**Subject line:** Comments to draft WR-1 Disposal EIS

**Environmental Impact Statement  
In Situ Decommissioning of WR-1 at the Whiteshell Laboratories Site  
Pinawa, Manitoba,  
Rev. 1.**

**RE: Comments to Environmental Impact Statement  
In Situ Decommissioning of WR-1 at the Whiteshell Laboratories Site Pinawa, Manitoba,  
Rev. 1 (Golder et al. 2017)**

**Figure 1: Radionuclide Inventory with Decay for WR-1 (note: limited to key long-lived radionuclides exceeding  $1 \times 10^8$  Bq). Note: Estimates for the Glaciation Period from 50,000 years to 140,000 years with possible error bands are provided.**

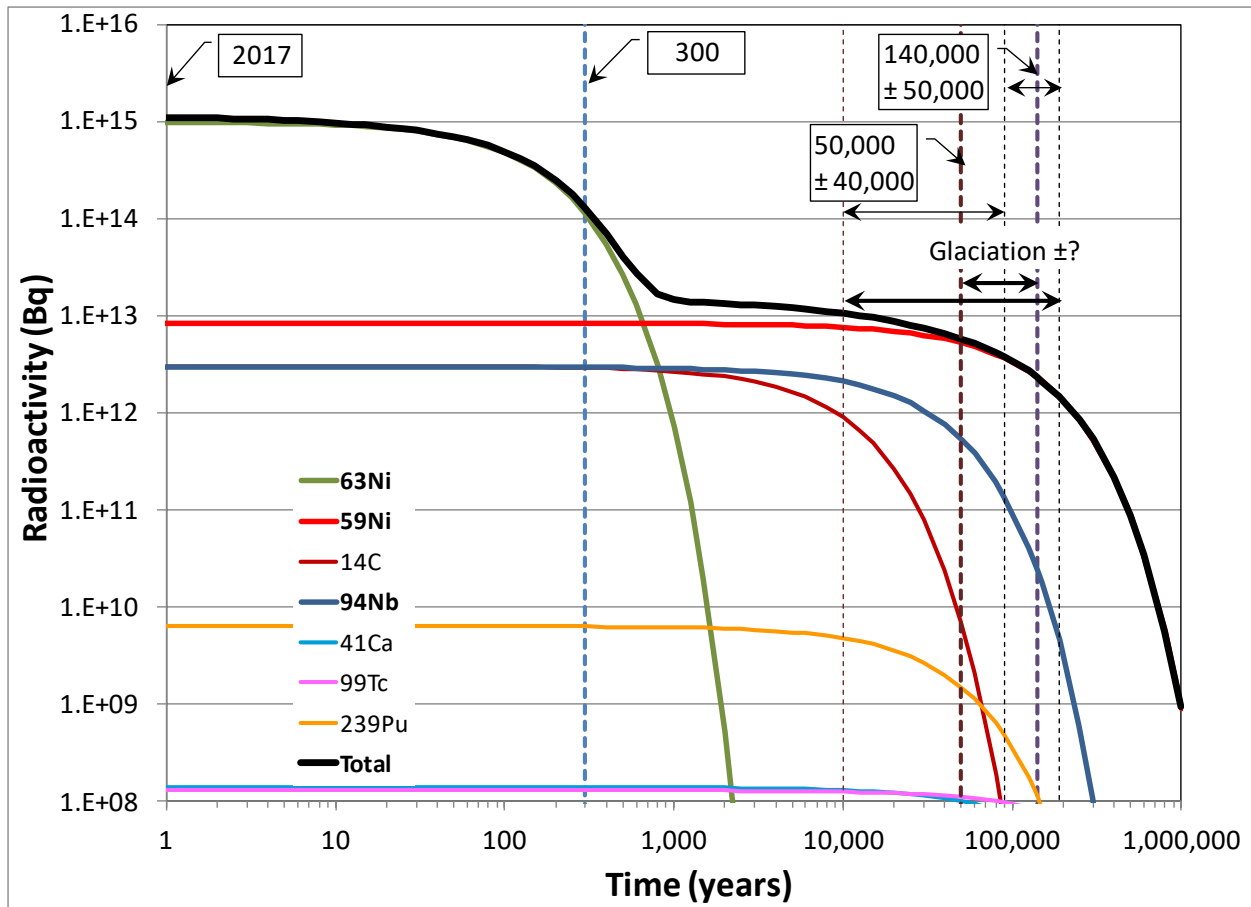
Nowhere within the document is there a figure or table documenting the decay of the identified key long-lived ILW radionuclides over time (i.e., the rate at which the hazard naturally diminishes) as originally identified in our first set of comments (Baumgartner et al. 2016 Jul 03). Figure 1 provides such an illustration showing the relationships over time before any consideration of loss of radionuclides by groundwater leaching. It also highlights the radionuclide inventory at the estimated cessation of the next glaciation, 140,000 years from now, regardless of where the radionuclides may have been redistributed or dispersed. This creates a strong visual image for the reader and provides a comparative reference timeline in discussing further arguments, such as the relative insignificance of  $\pm 50,000$  years to the 140,000 year intraglacial estimate. The beginning of the next glaciation is set here at 50,000 years  $\pm 40,000$  years assuming a nominal glacial duration of 90,000 years as suggested in Chapter 10.

As can be seen in Figure 1 and Table 1, the radionuclide inventory is dominated by the two nickel congruent-release radionuclides, Ni-59 and Ni-63, in the stainless-steel alloys of the reactor vessel and components. Stainless steel was chosen for the reactor components due to its high corrosion resistance in water, particularly in chloride-free environments. The virtual total dissolution of the congruent-release radionuclides are estimated in Table 2 (derived from Table 4-3 in Bishop 2017). The solute transport model used the Full Corrosion (2-way) values which is based on the simultaneous attack on both sides (inside and outside surfaces) of the reactor components (e.g., Calandria Vessel - 63,500 years and stainless-steel Fuel Channel - 17,800 years) (Bishop 2017). This simultaneous attack on both sides of all of the components

The stated release of the nearly total nickel radionuclide inventory within 140,000 years is highly suspect and needs a more valid supporting argument. Most of the Ni-59, as shown in Figure 1, should be available for glacial exhumation of WR-1. Even if the total nickel inventory is released as described in the EIS, the proponents will have to show that the solubilized nickel is not reconcentrated downstream of the WR-1 site through sorption and/or bioaccumulation.

**Figure 2: Nested Reactor Components (thermal shields, calandria vessel, calandria tubes and fuel channels) (Golder et al. 2017)**

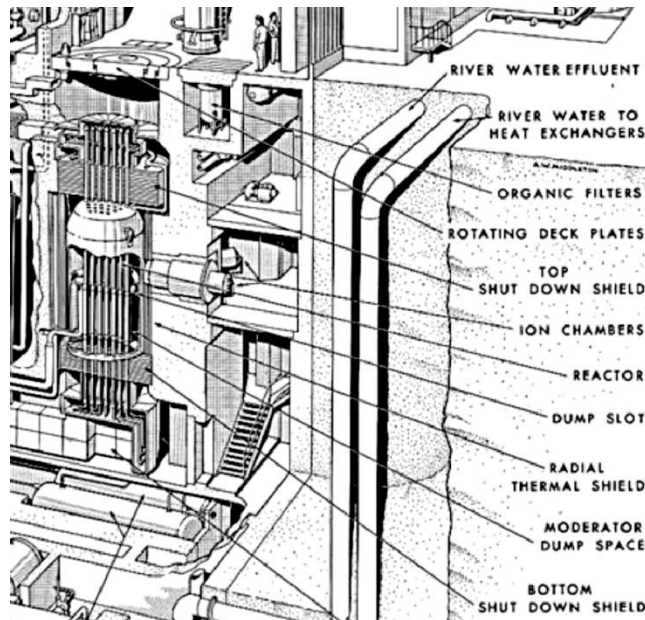
CNL plans to fill all the voids of the WR-1 system with grout and to seal all penetrations to prevent/reduce groundwater ingress and to provide long-term structural support. WR-1 (Figure 2) is compartmentalized as itemized in Table 2 to specifically separate and control the flow of gases and liquids within the reactor system. This sealing prevents the simultaneous corrosion of all reactor component surfaces regardless of grouting. The incorrect consequence of the proponent’s unrealistic 2-way corrosion process is that few to no radionuclides remain within the WR-1 structures at the time of the next intraglacial period (i.e., 140,000 years of leaching in column 5 of Table 1).

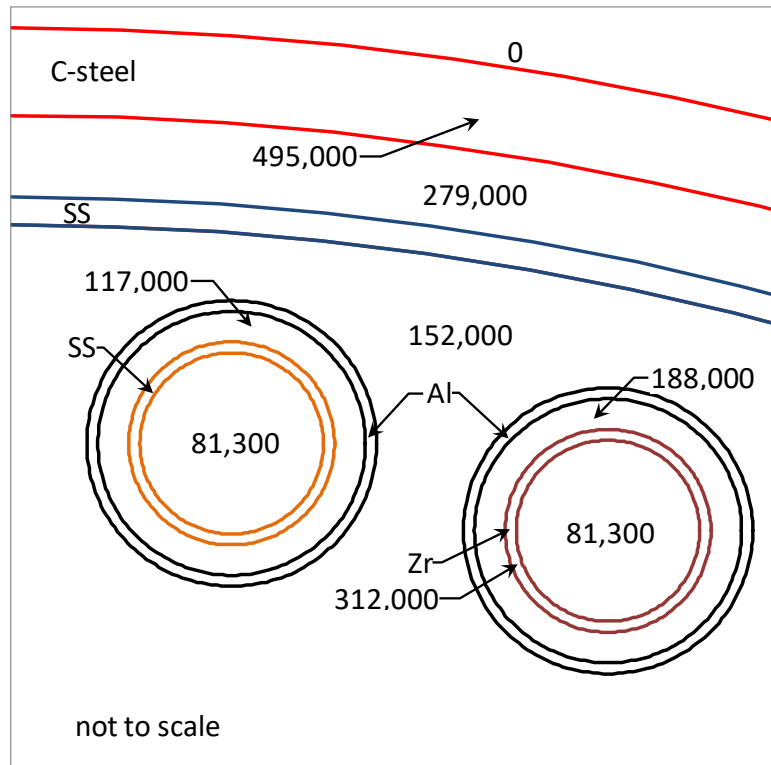
Corrosive attack can only begin from the outside of the outer-most components of the reactor system, namely the thermal shield and primary heat transport (PHT) pipes (e.g., 8” Sch 40), identified as Step 1 in Table 2 and as shown in Figure 3. All the remaining components of the system are effectively sealed from the groundwater environment by these two metallic barriers. This one-way attack effectively doubles the time to breach through and fully corrode these two components, as shown as Full Corrosion (1-way) in Table 2. Note also that the greater thickness of the Thermal Shields increases their time for breaching and full corrosion (e.g., 1,270,000 years) as compared to the PHT pipes (e.g., 81,300 years) (Sequence Year 81,300) by a factor of ~15 (Full Corrosion (1-way) in Table 2).

The next Step (2) is the one-way penetration of the Fuel Channels as accessed internally from the PHT pipes. The one-way corrosion rate through the stainless-steel (SS) Fuel Channels is an order of magnitude faster (e.g., 35,600 years) than through the two zirconium-alloy Fuel Channels (e.g., 356,000 years) (Full Corrosion (1-way) in Table 2). After the SS Fuel Channels are breached (Sequence Year 117,000), their surrounding aluminum (Al) Calandria Tubes are attacked (Step 3) from the inside surfaces which take the same amount of time to breach (e.g., 35,600 years) (Sequence Year 152,000).

The one-way corrosion of the Calandria Vessel takes 127,000 years to complete (Sequence Year 279,000) (Table 2). The one-way corrosion of the Al Calandria Tubes takes 35,600 years (Sequence Year 188,000). Meanwhile, the corrosion of the zirconium-alloy Fuel Channels becomes a two-way process, shortening the time for corrosion completion (Sequence Year 312,000).

With the breaching of the Calandria Vessel (Sequence Year 279,000), the corrosion of the Thermal Shield becomes a two-way process, shortening the time for completion (Sequence Year 495,000). Note that the high-pH (alkaline) environment of the cementitious materials (concretes and grouts) is not considered in any known analyses by CNL or their contractors and should significantly reduce the corrosion rates. Nor is the supply rate of corrosion reactants considered in any analyses.

**The EIS needs to illustrate the likely corrosion processes and rates for congruent and surficial radionuclide release taking into account the contacting ground water-flow rates, high-pH chemistry, microbial activity under both oxic and anoxic conditions, glacial permafrost and hindered groundwater replenishment conditions.** Note that the EIS acknowledges that glaciation will hinder groundwater flow, not only limiting migration of contaminants from the reactor into the geosphere but concomitantly limiting the supply of corrosive reactants, such as oxygen. For example, the annual flow rate through the backfilled WR-1 structure of 0.167 to 0.193 m<sup>3</sup>/day (Bishop 2017) will approach zero during the permafrost and glacial cover periods, possibly leaving diffusion as the primary transport mechanism for reactant and product transport. Only after rupture and exhumation of the WR-1 structure by the glacier can a complete two-way corrosive attack occur on the remaining structures.
